**FRESNO EL PASEO  
ENVIRONMENTAL  
IMPACT REPORT**

**SCH#2008011003**

**OCTOBER 2010  
REVISED:  
NOVEMBER 2010**

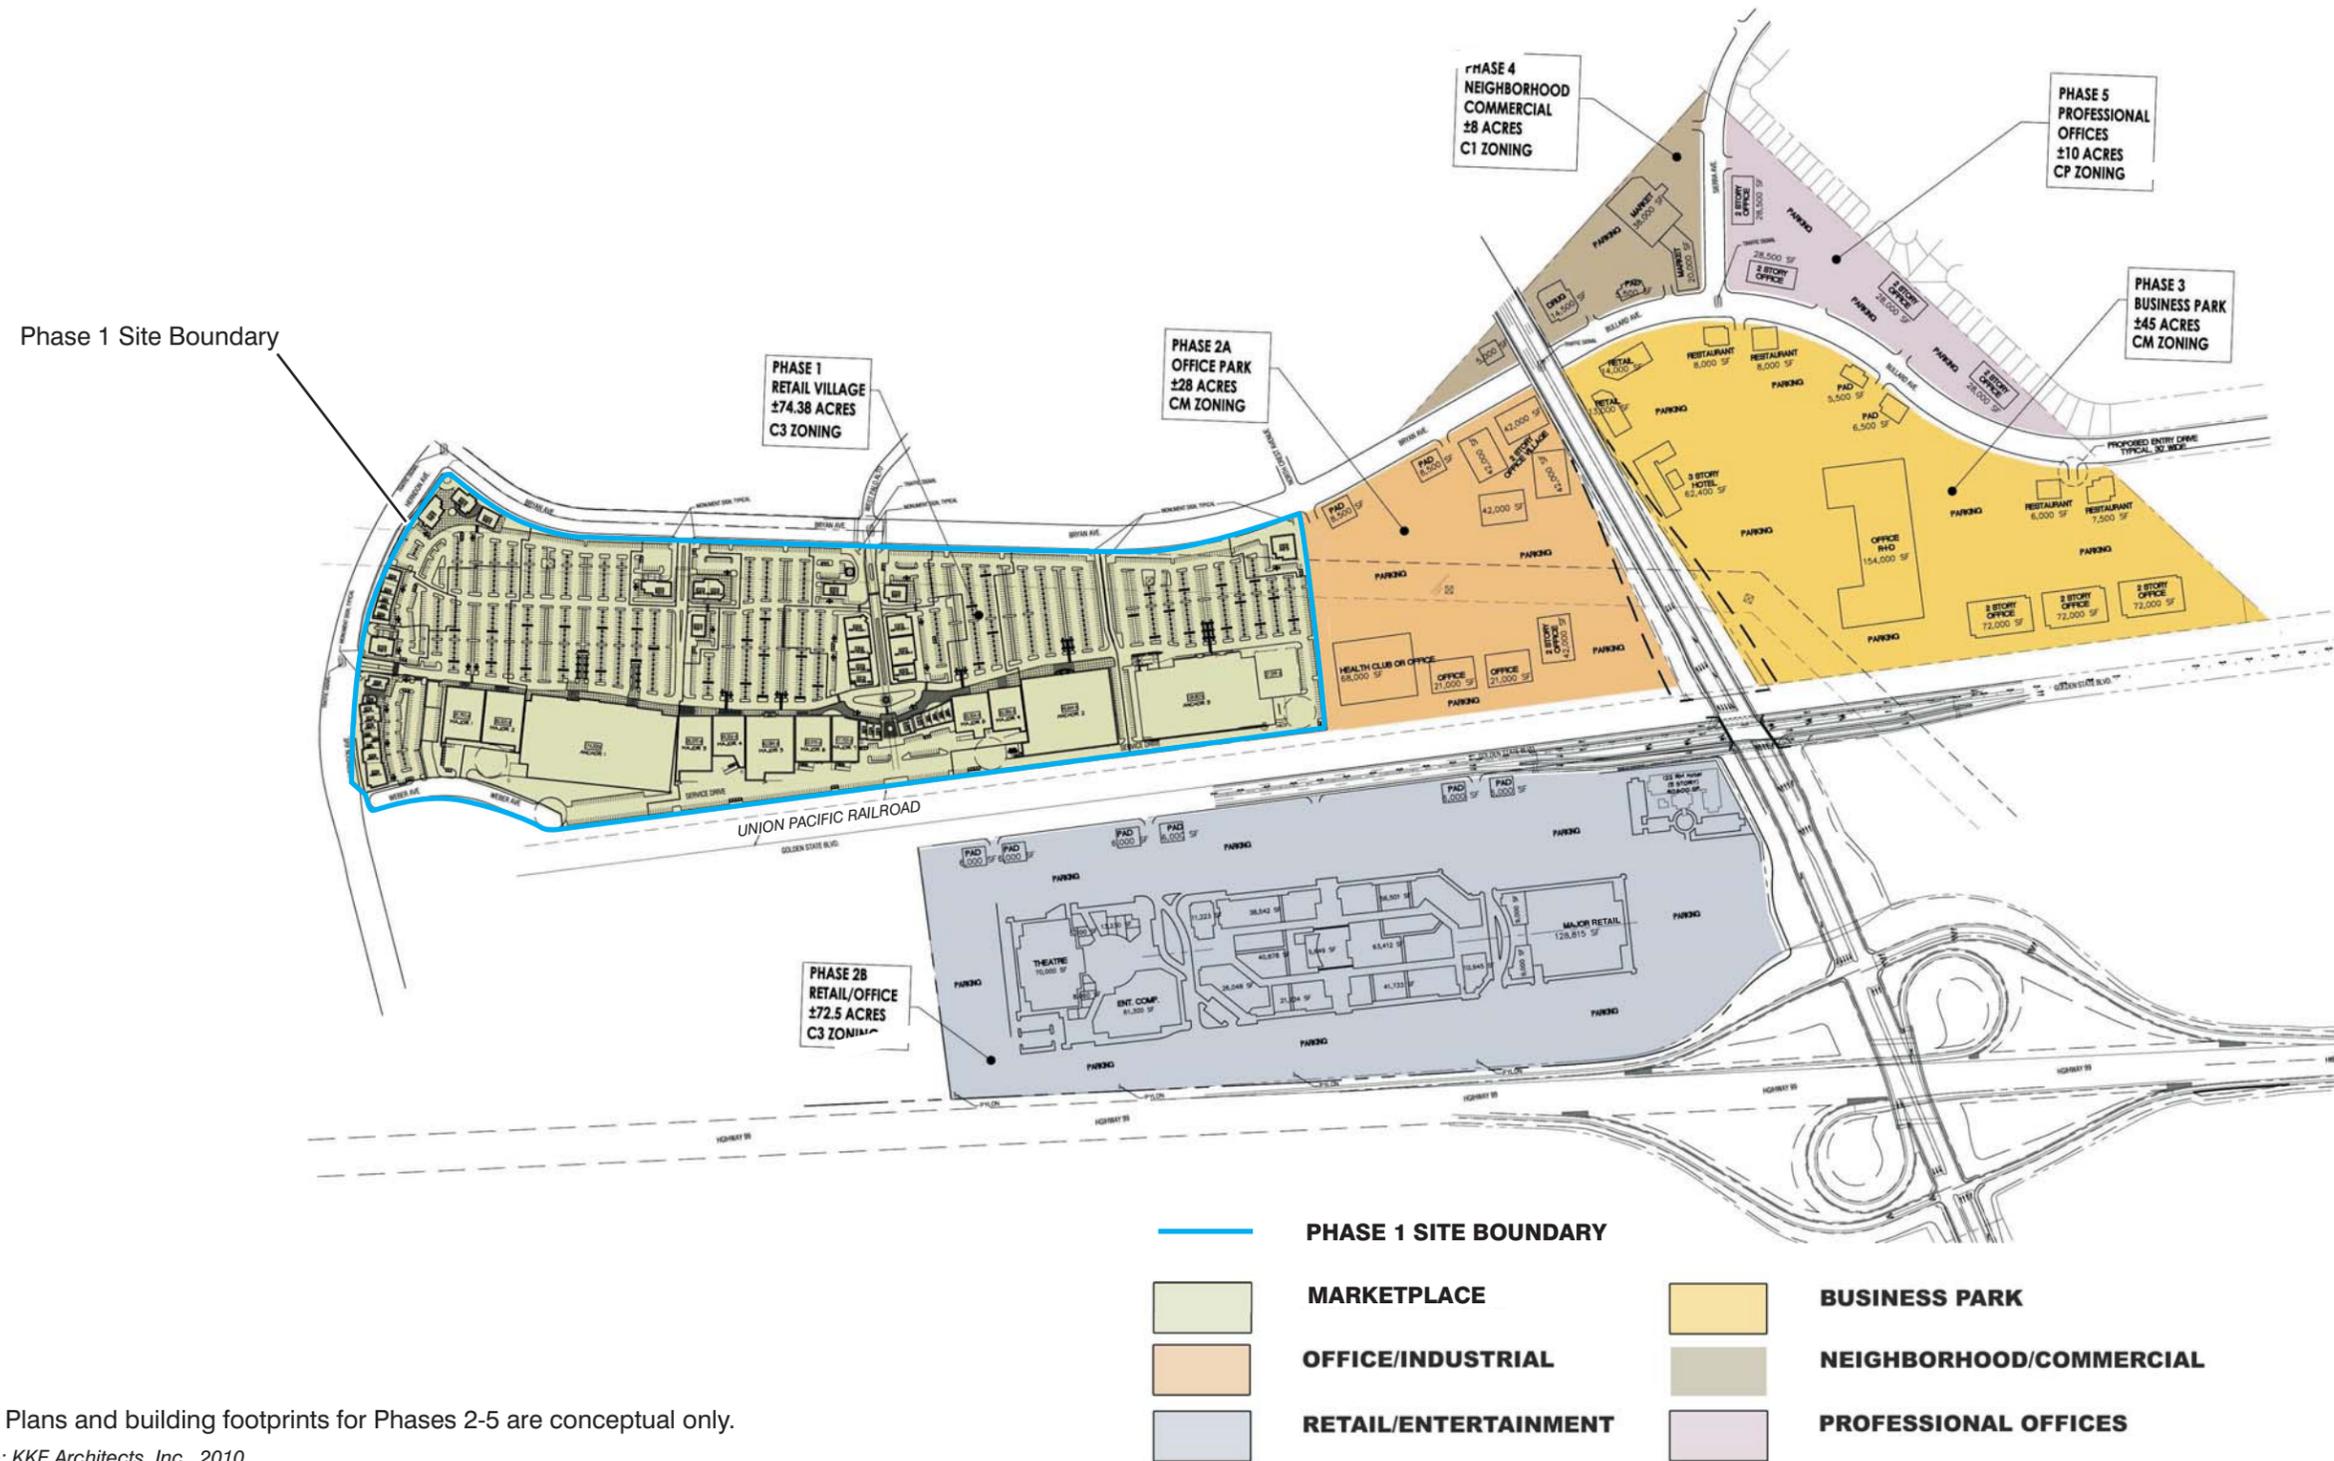
**Page 3-11, Figure 3-4, Master Site Plan.** This figure has been modified to correct the Phase 1 Site Boundary to delineate the entire Marketplace area. The corrected Phase 1 Site Boundary is applicable to all figures of the DEIR and Recirculated DEIR.

Please see revised Figure 3-4 in Chapter 3.6, *DEIR Revised and New Figures*, of this FEIR.

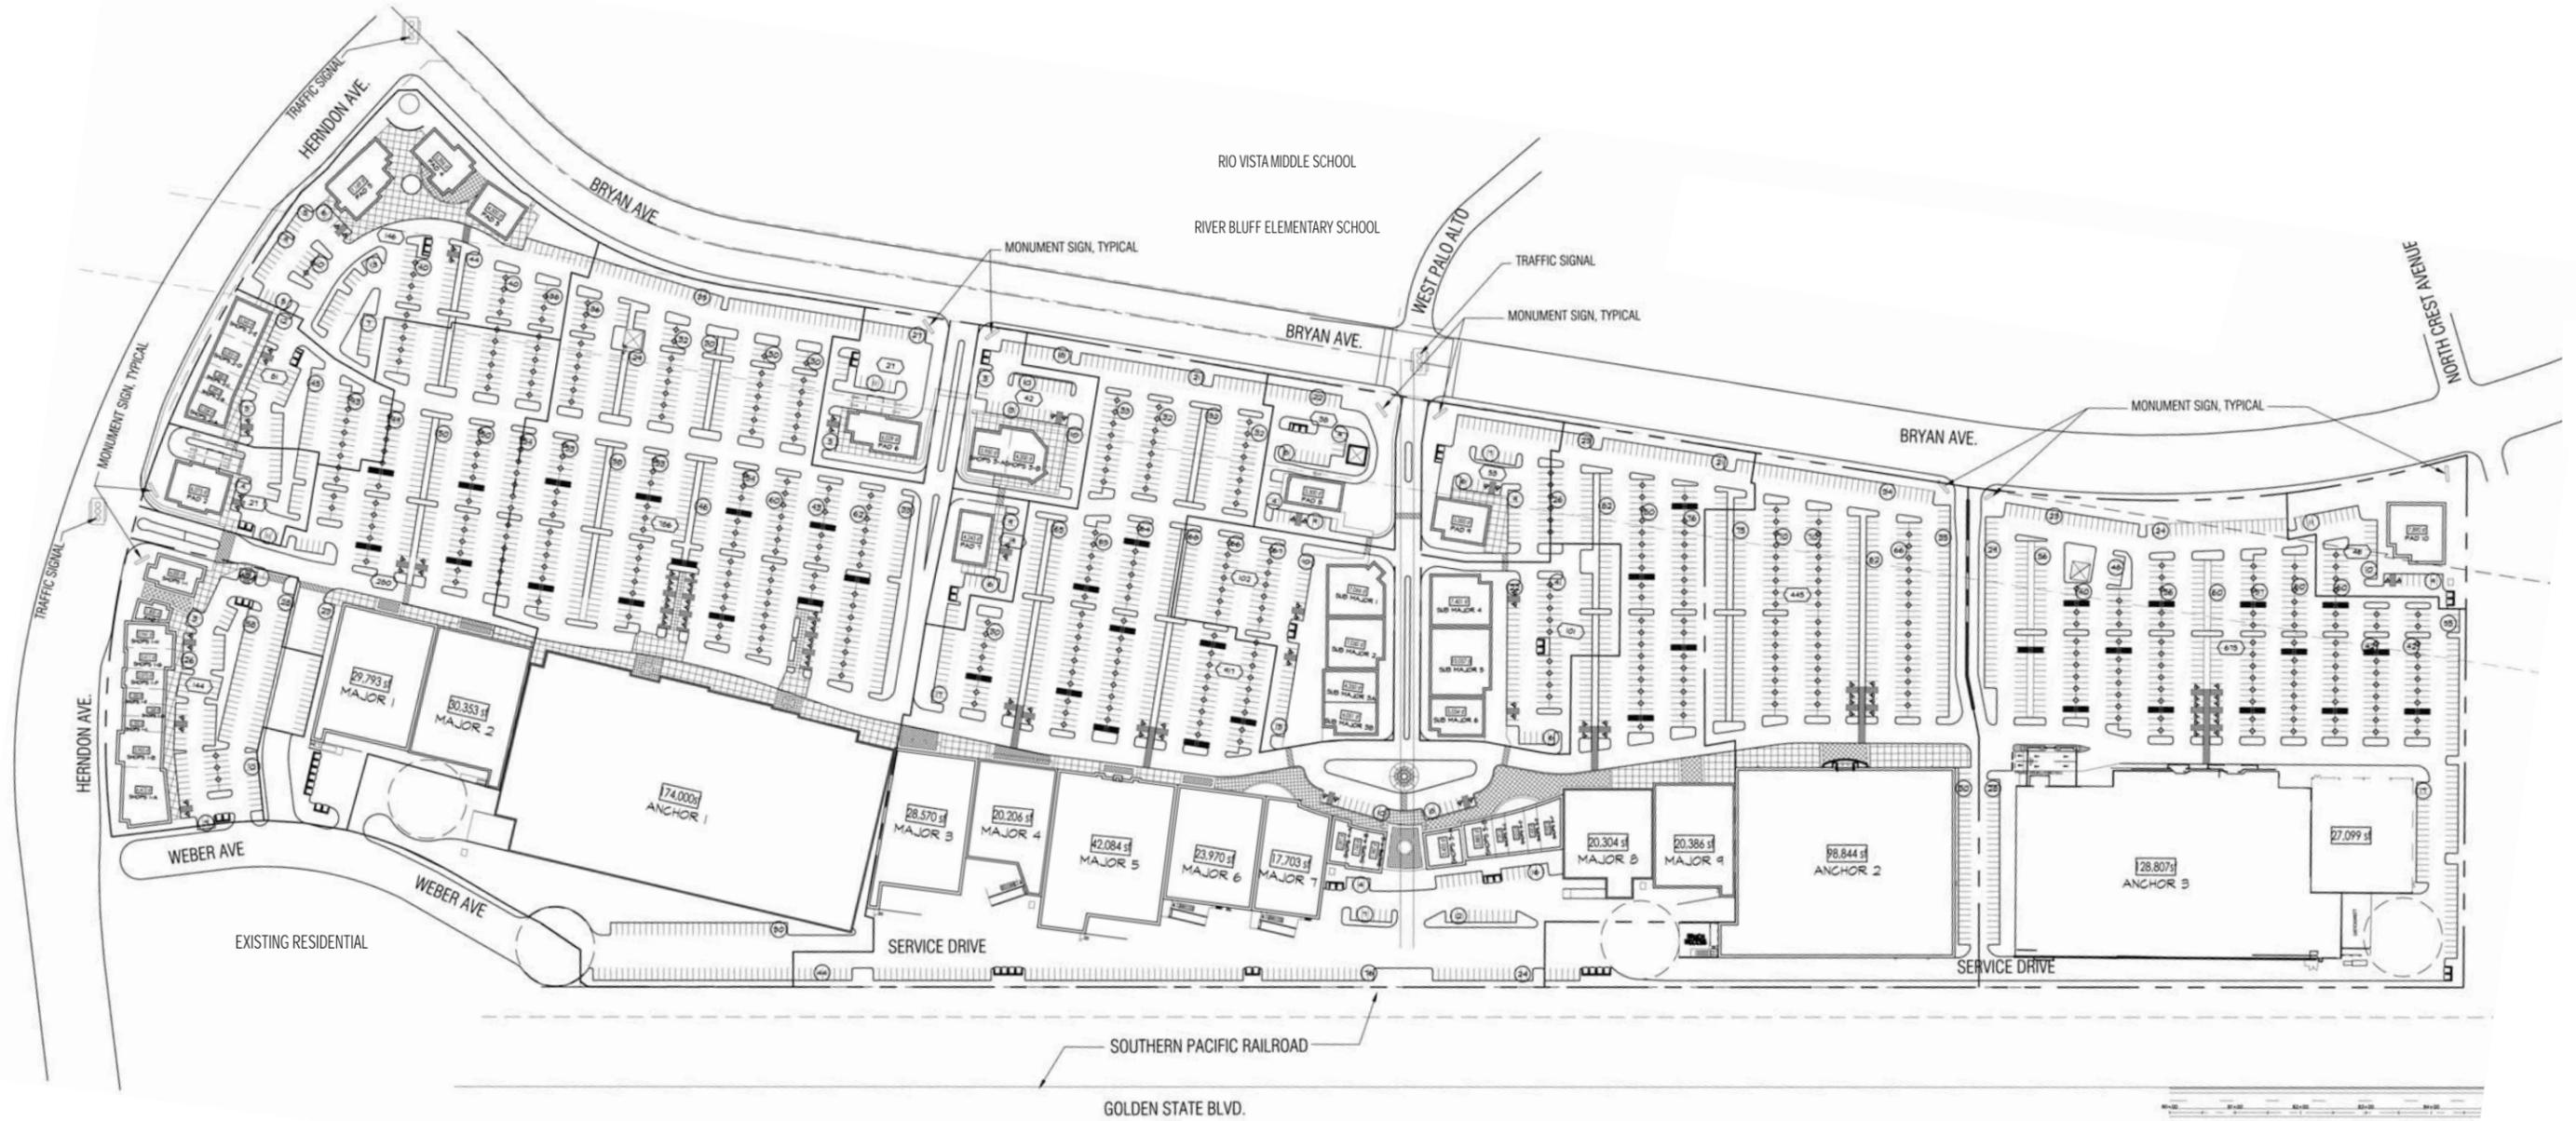
Figure 3-5 shows the Marketplace El Paseo, however it does not delineate the at-grade railroad crossing located at Herndon Avenue and Golden State Boulevard. This is a **significant** oversight and omission since there is no provision for future right-of-way along the frontage of this project for a Grade separation either over or under the existing track alignment. This needs to be a requirement of the City in order to preserve the necessary right-of-way for the foot print of such a

**Page 3-13, Figure 3-5, Marketplace El Paseo.** This figure has been revised to show the Marketplace El Paseo site plan. The Marketplace El Paseo site plan shown in this figure is applicable to all figures of the DEIR and Recirculated DEIR.

Please see revised Figure 3-5 in Chapter 3.6, *DEIR Revised and New Figures*, of this FEIR.

Photo Location Map and Photographs of Site and Surrounding Area

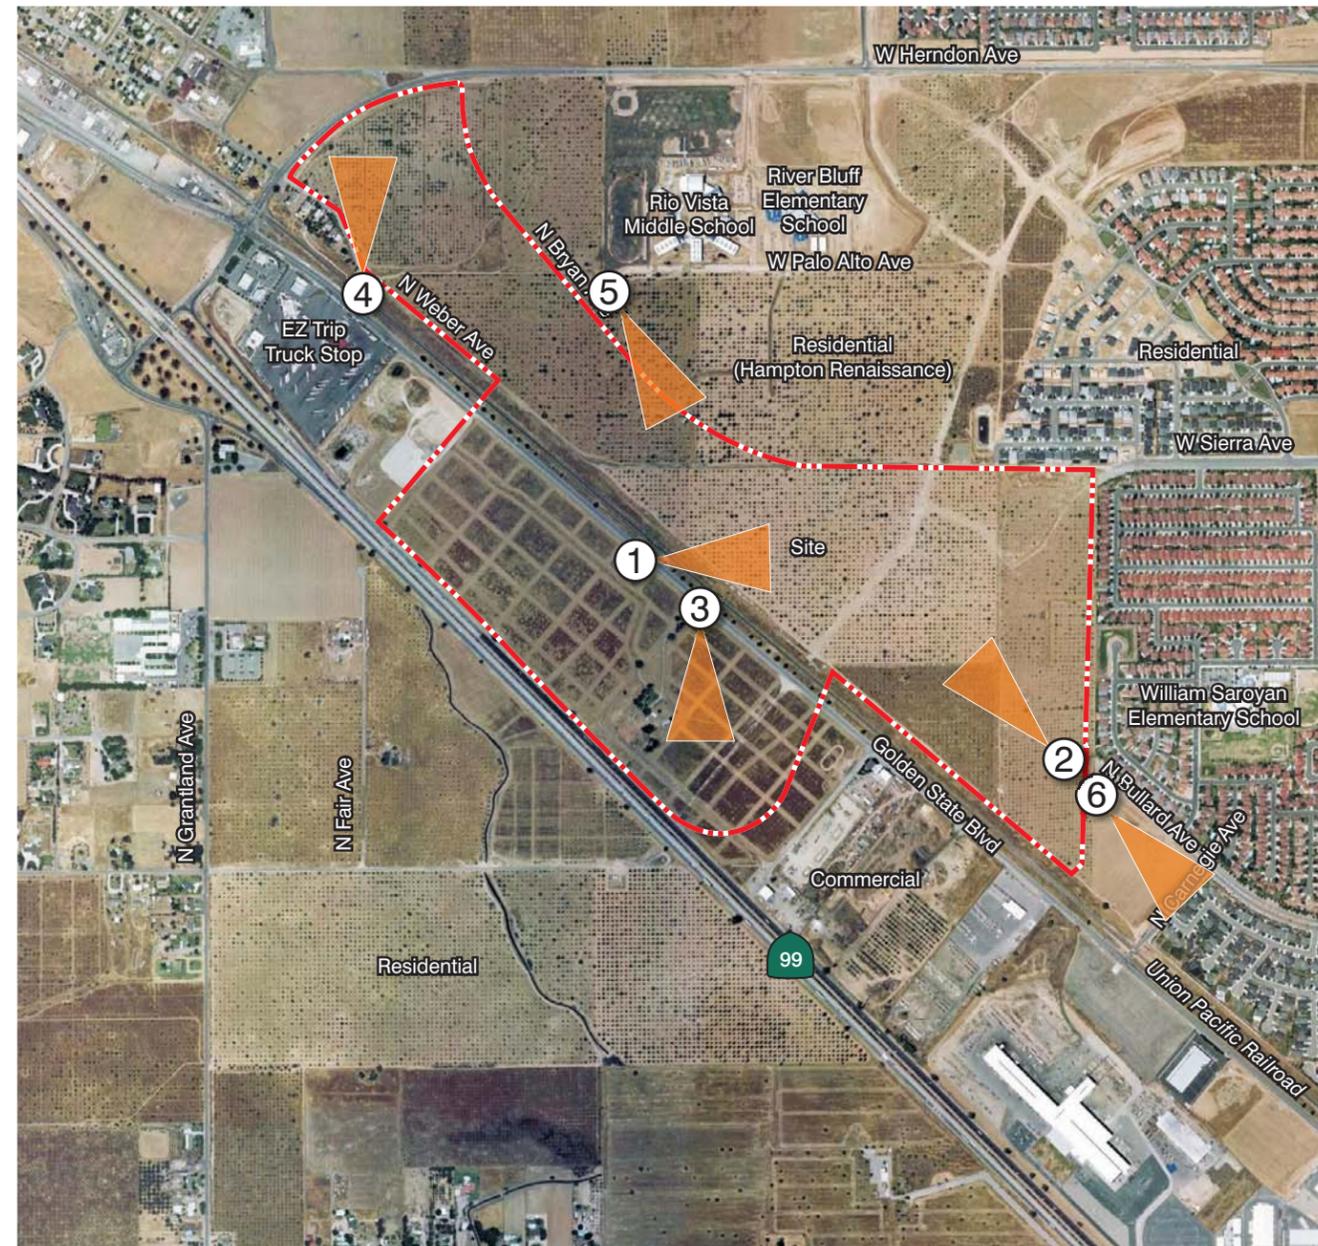
In addition, the commenter also identified the mislabeling of River Bluff Elementary School and Rio Vista Middle School on Figure 4-1. The corrected figure is included in Chapter 3.6, *DEIR Revised and New Figures*, of this FEIR.

**Page 4-3, Figure 4-1, Photo Location Map and Photographs of Site and Surrounding Area.** This figure has been modified in response to Comment No. A8-2, from the Central Unified School District to show the correct locations of Rio Vista Middle School and River Bluff Elementary School.

Please see revised Figure 4-1 in Section 3.6, *DEIR Revised and New Figures*, of this FEIR.

The Planning Center • New Figure 5.9-4

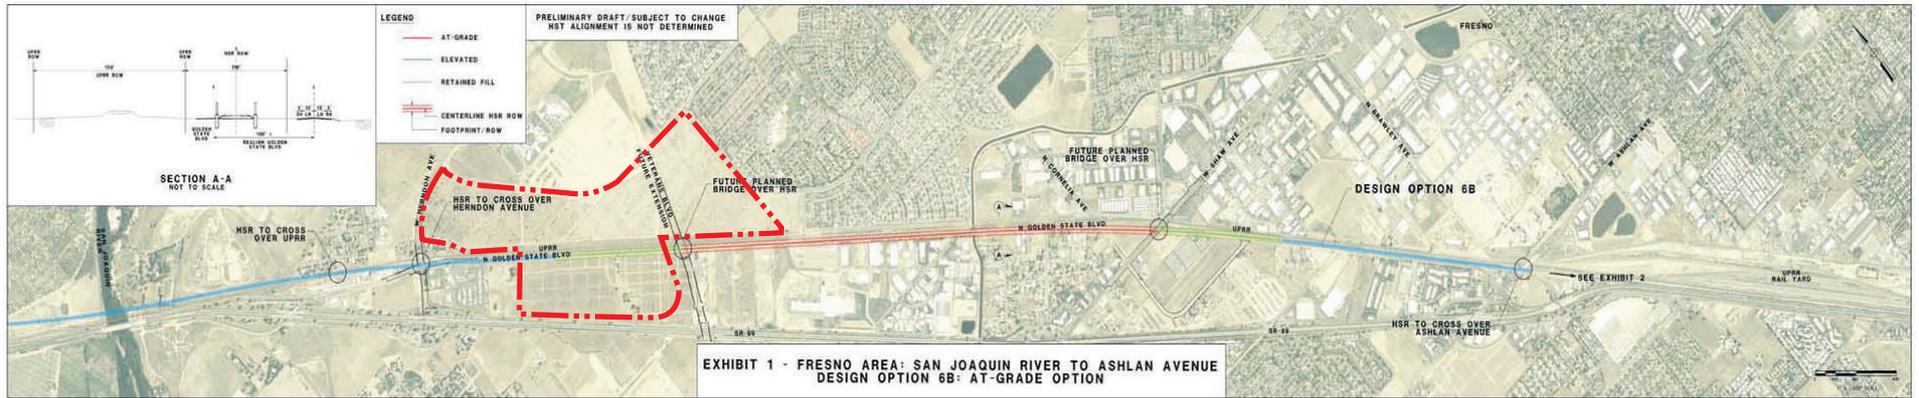
The exact design of the HSR next to the project site is still being determined, but two preliminary design options are presented in Figure 5.9-4. Neither one of the alignment alternatives would affect Phase 1 of the El Paseo for which the EIR is prepared at a project-level detail. The alignment could impact future phases of El Paseo, particularly Phase 2A, for which the site plans are conceptual.
